UNITED STATES PATENT AND TRADEMARK OFFICE

Office Action Summary	Application No. 10/565,491	Applicant(s) SCUZZO, GIUSEPPE	
	Examiner Sunil K. Singh	Art Unit 3732

DETAILED ACTION

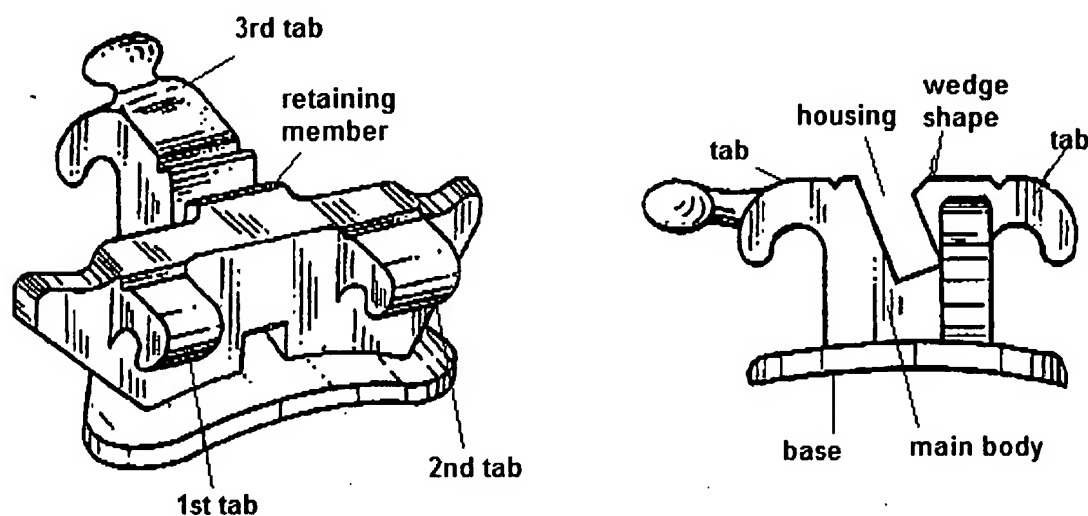
10. Claims 1,17-22, and 25-29 are rejected under 35 U.S.C. 102(b) as being anticipated by Viazis (US D367116).

Viazis discloses an orthodontic bracket (Figs. 1-20) that includes: a base (see Figs. 2 and 4 that are reproduced below); a main body (see Fig. Below) raised from base constructed in a single piece with the base having a plurality of projecting engaging tabs (Fig. Below) that are capable of engaging and retaining a binding system; a housing (Fig. Below) for an orthodontic wire, the housing being interposed between the tabs and inclined so to form an acute angle with respect to the base (see Fig. 2); the acute angle opening towards a bottom of the tooth when the bracket is fastened onto the inclined lingual side of the tooth; a retaining member (see fig. Below) that faces the housing and extends only along a limited segment of the latter and is capable of abutting against the arch wire (See Figs. 2 and 4); wherein the retaining member is in the form of a projecting fin having a substantially wedge shaped profile (see Fig. Below); the retaining member is in a centered position relative to the housing; the retaining member is integral with the remaining parts of the bracket (Figs. 2,4); the retaining member constructed in a single piece with the remaining part of the bracket itself (See Fig. Below); the retaining member is arranged superiorly to the tabs (Fig. 4); wherein the plurality of tabs comprises a first, a second, a third tab (Fig. Below) and having a rounded profile; wherein the first and second tabs are arranged at the opposite side of

the housing (Fig. Below); wherein the retaining member is arranged between the first and second tab and is oriented in the opposite direction (Fig. Below); wherein the housing is in the form of a groove extending transversely relative to the base; and wherein the housing is defined by two or more walls set longitudinally side by side, having a cross section with a broken-line profile (Figs. 2,4,8,9,11,15,16,18).
